Staff Report

Re: PLNSUB2014-00439/00441 Sugar House Townhomes Planned Development and Preliminary Subdivision

Planned Development & Preliminary Subdivision

PROPERTY ADDRESS: 2204 S 800 East
PARCEL ID: 16-20-107-024
MASTER PLAN: Sugar House
ZONING DISTRICT: RMF-35, Moderate Density Multi-family Residential

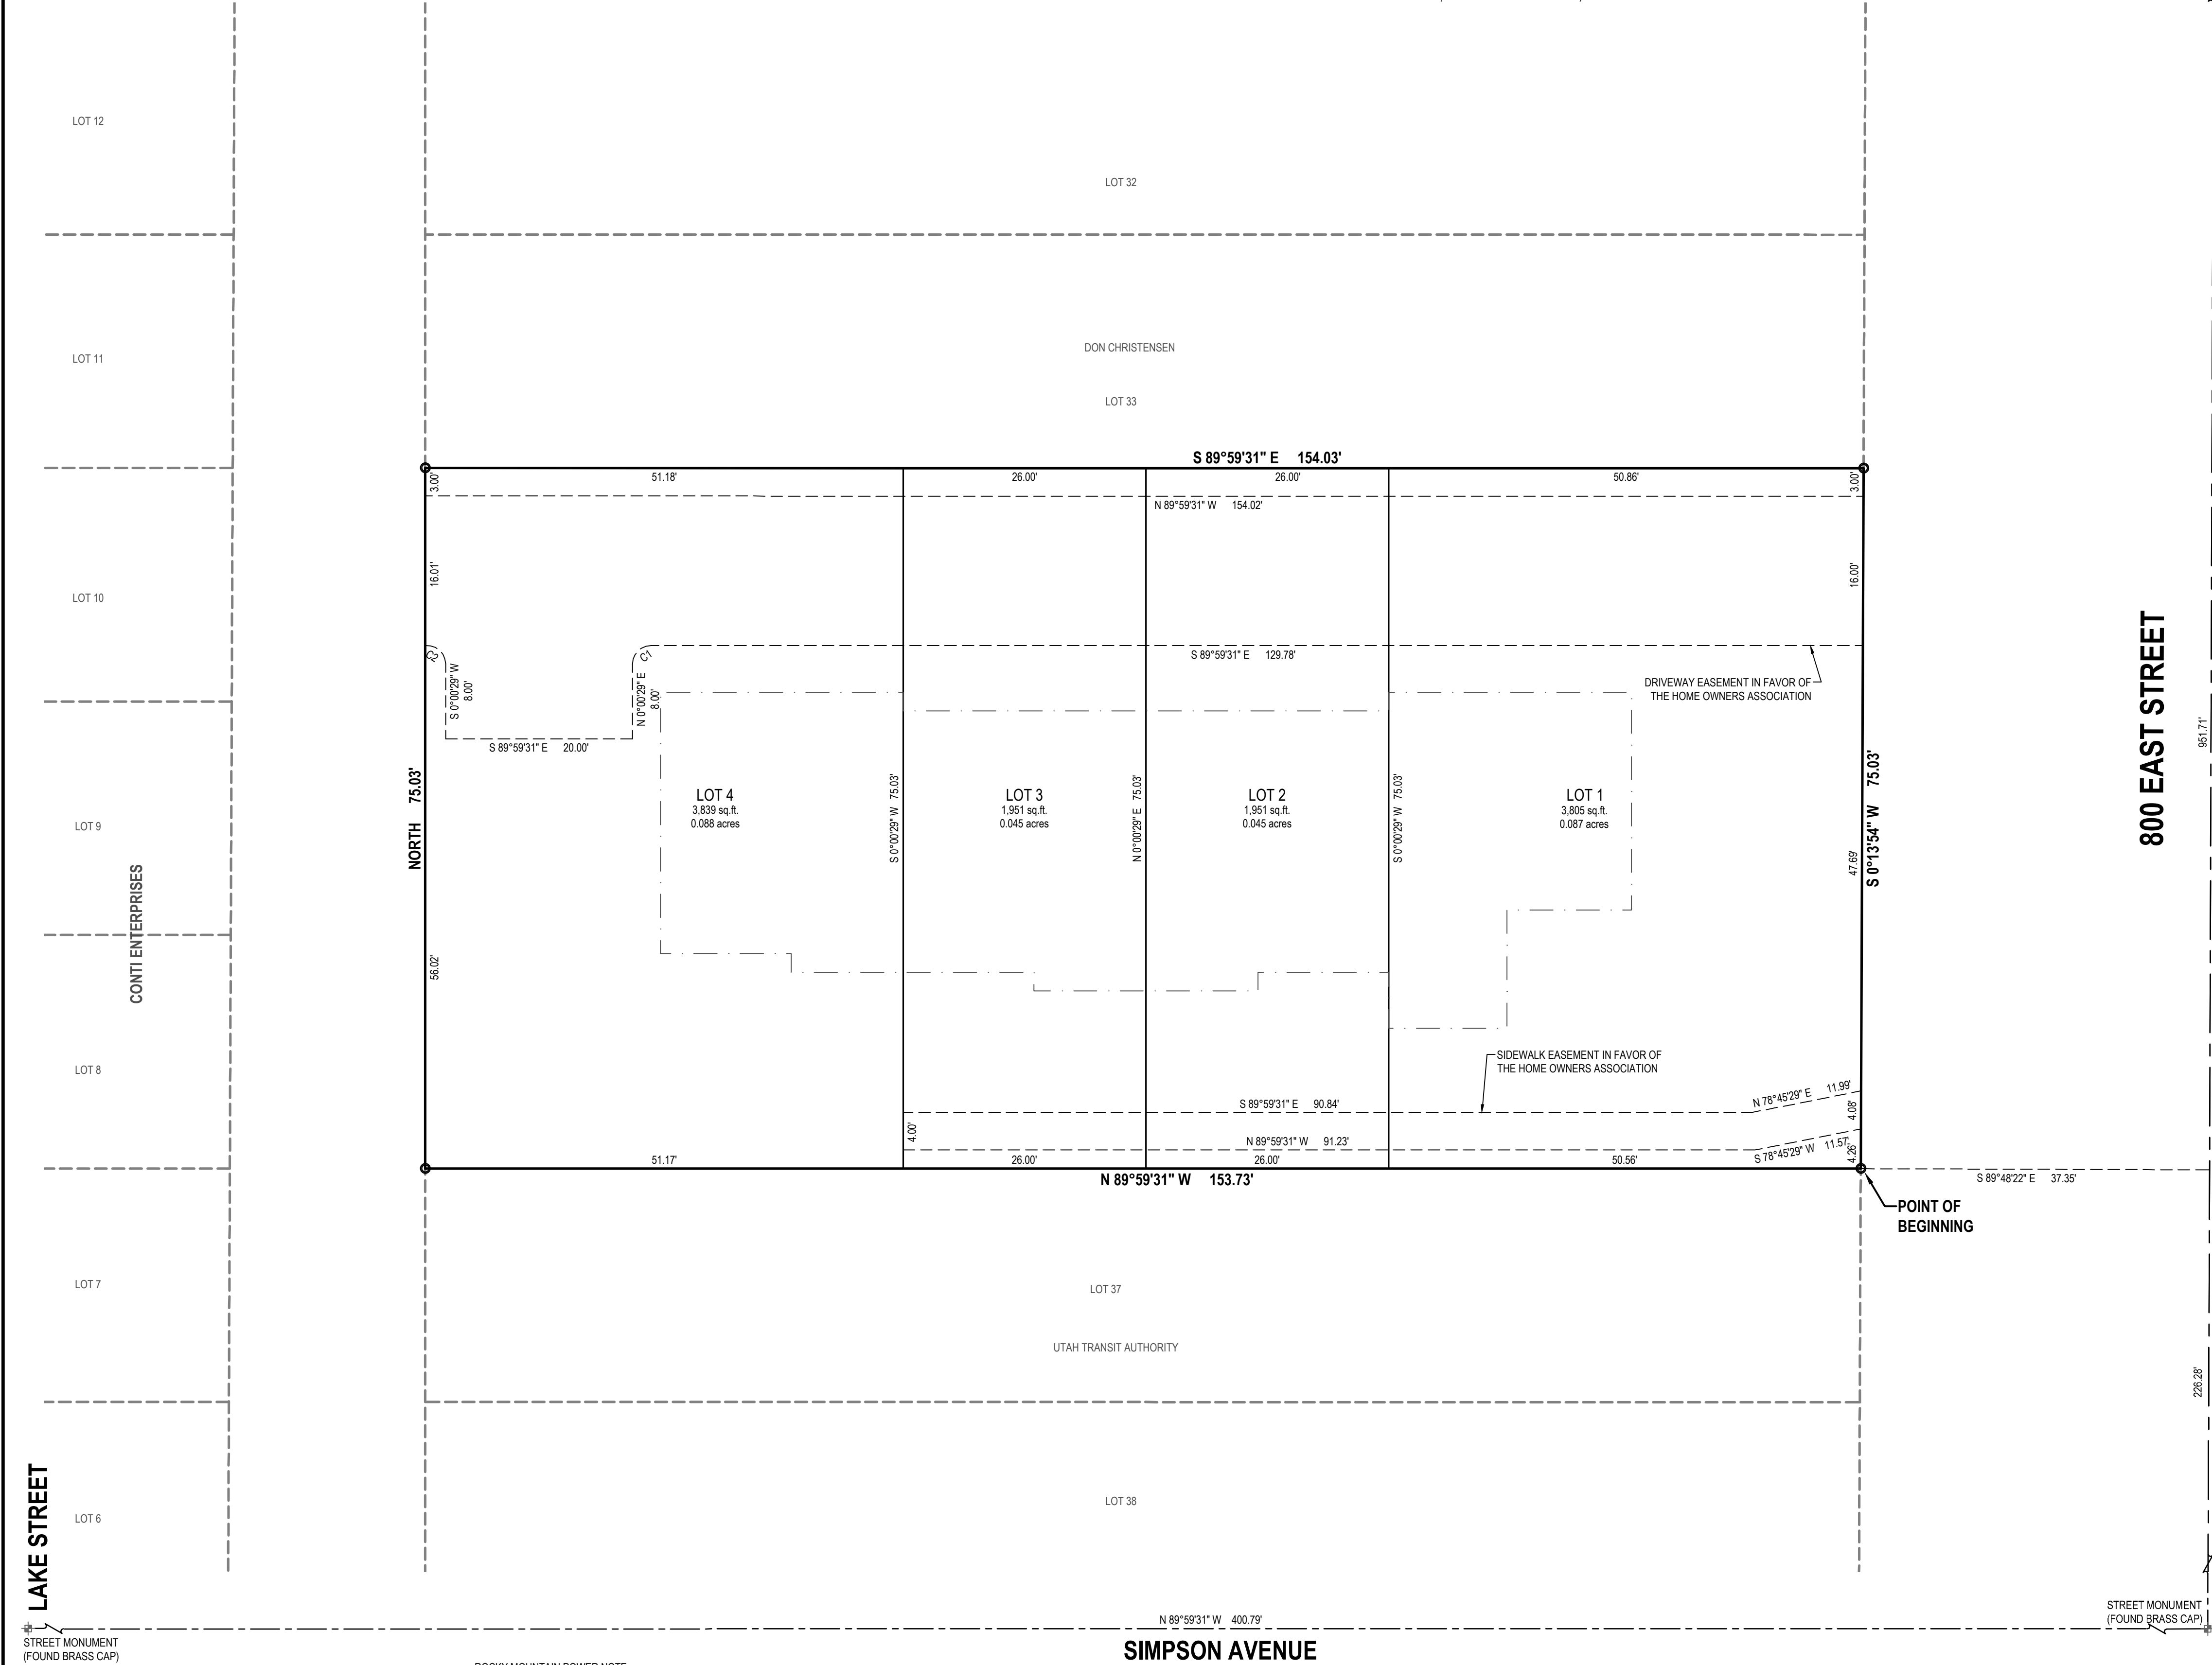
We have a number of concerns regarding this project. The utility plan currently shows a shared sewer line, but separate water services. Depending on how the PUD is setup, typically you have a shared water service with a master water meter in addition to the shared sewer service. If there are separate ownership and not bound by a HOA, then it would be expected that each lot would have its own water and sewer service. Regardless of the form used, there would need to be easements on the plat for the private utilities, either in favor of the HOA for ownership and maintenance of the master utility service or private water or sewer easements in favor of the individual lot owners (depending on the situation).

We will attempt to work with the applicant and fix the issues through plan review of the building permit, but with the current state of the utility plan and until there are decisions made on the way the lots are assembled, the preliminary plat cannot be approved at this time.

1
A-2.01
FRONT ELEVATION
SCALE: 3/16" = 1'-0" (24X36")
SCALE: 3/32" = 1'-0" (11X17")

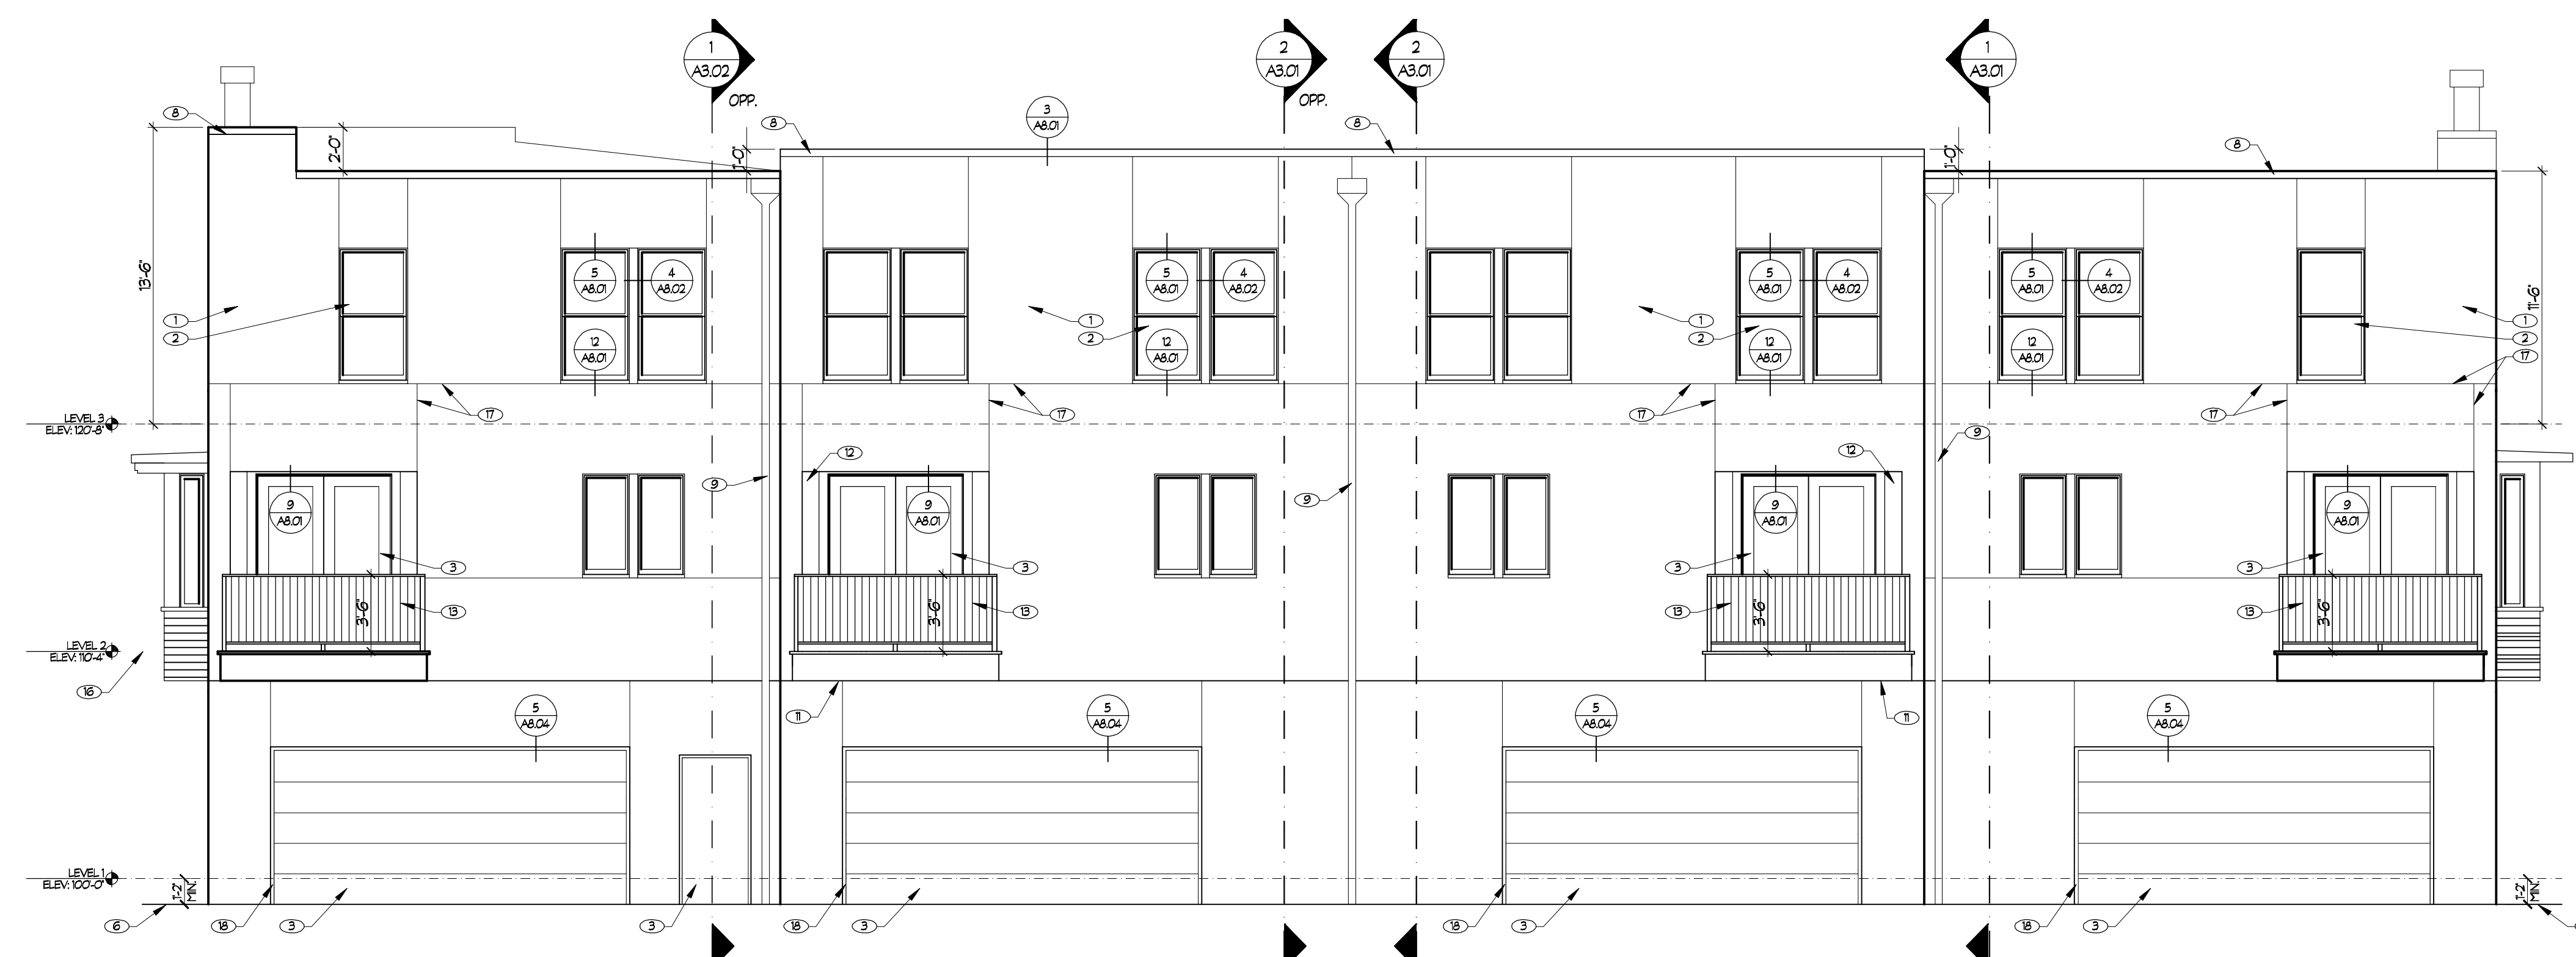
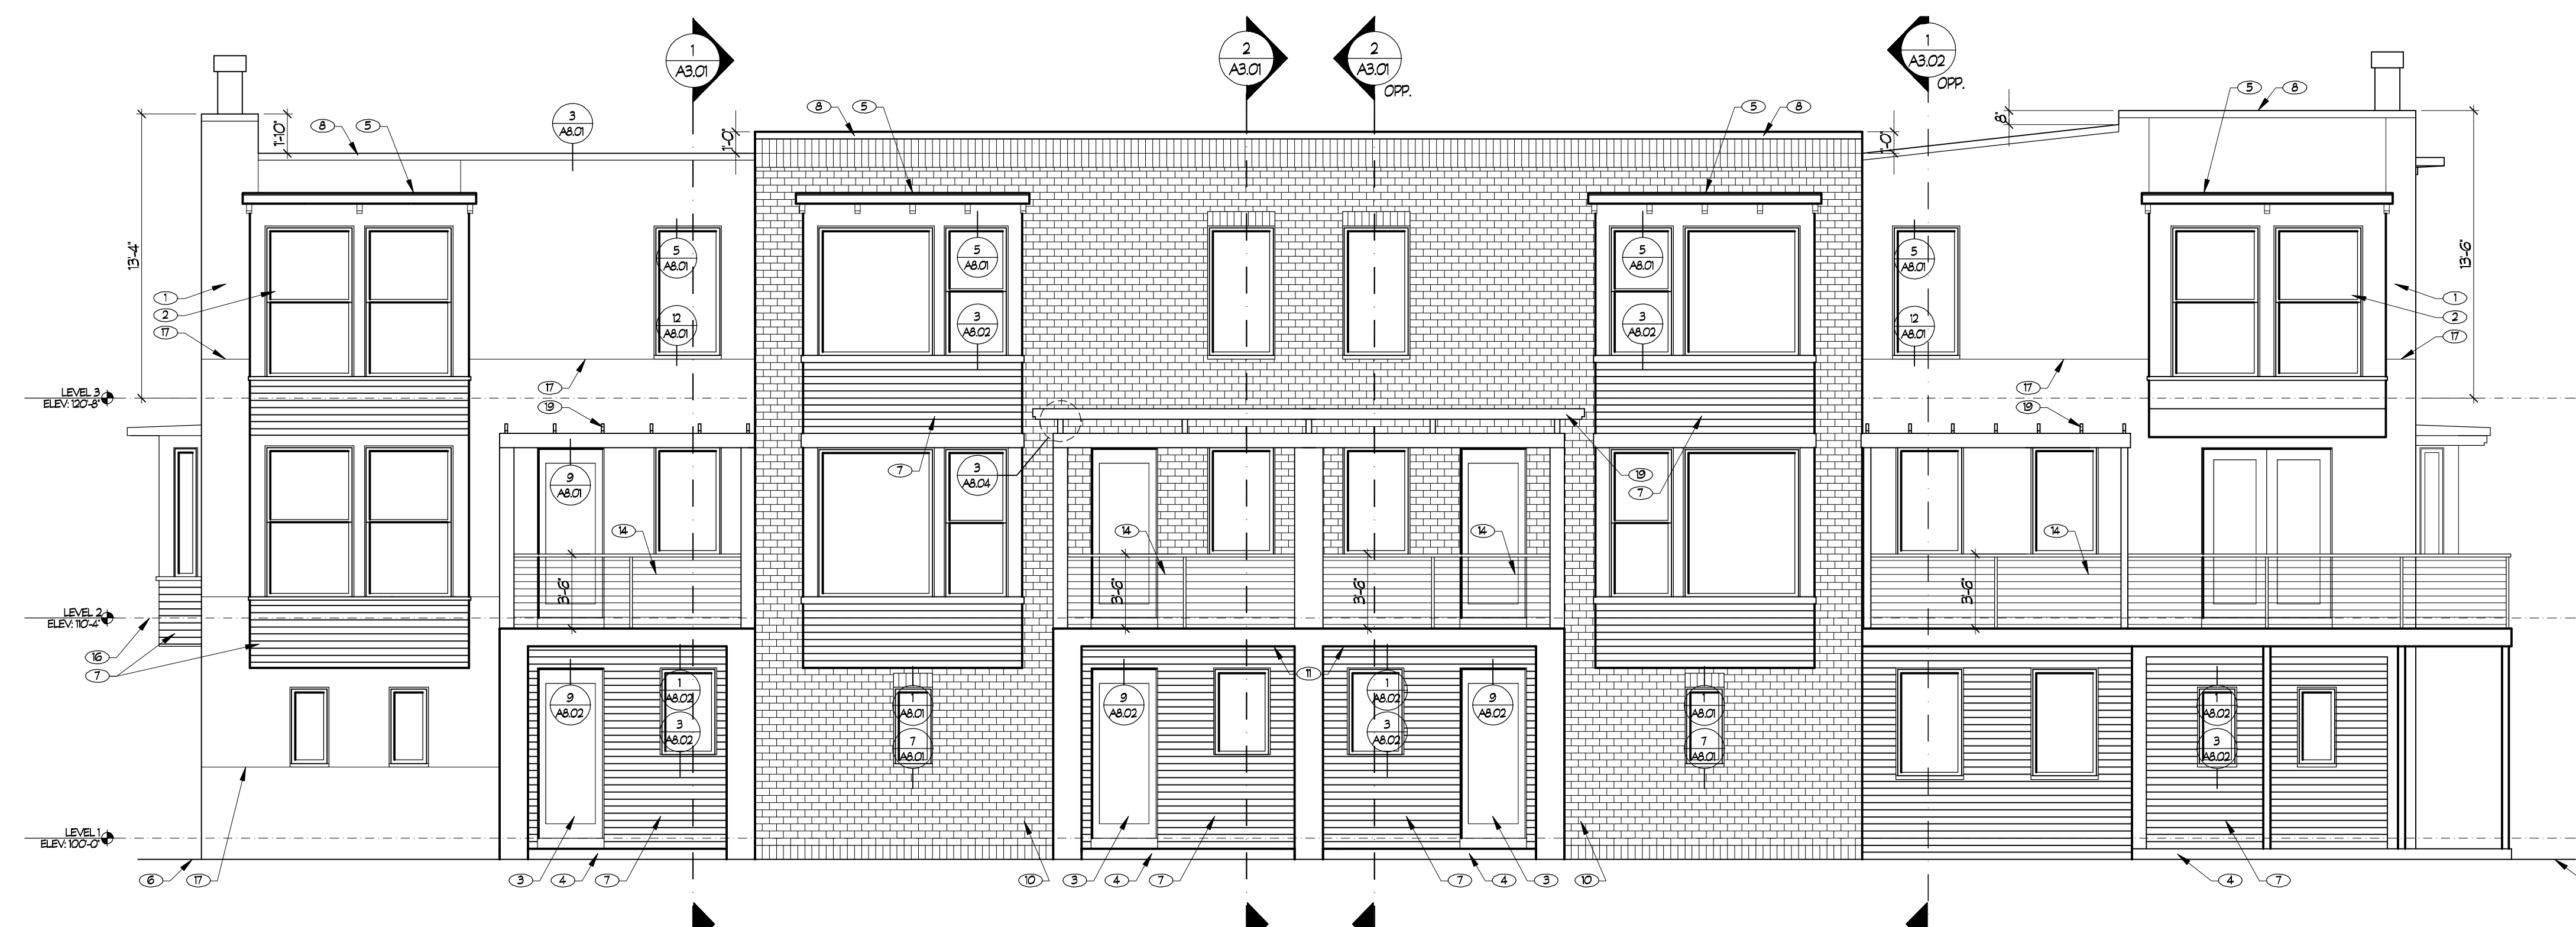
9. The surface coverage of all principal and accessory buildings shall not exceed 60% of the lot area. Please provide calculations.
10. The maximum building height is 35 feet, measured from existing grade to the roof deck. Please show building height on the Exterior Elevations as indicated.
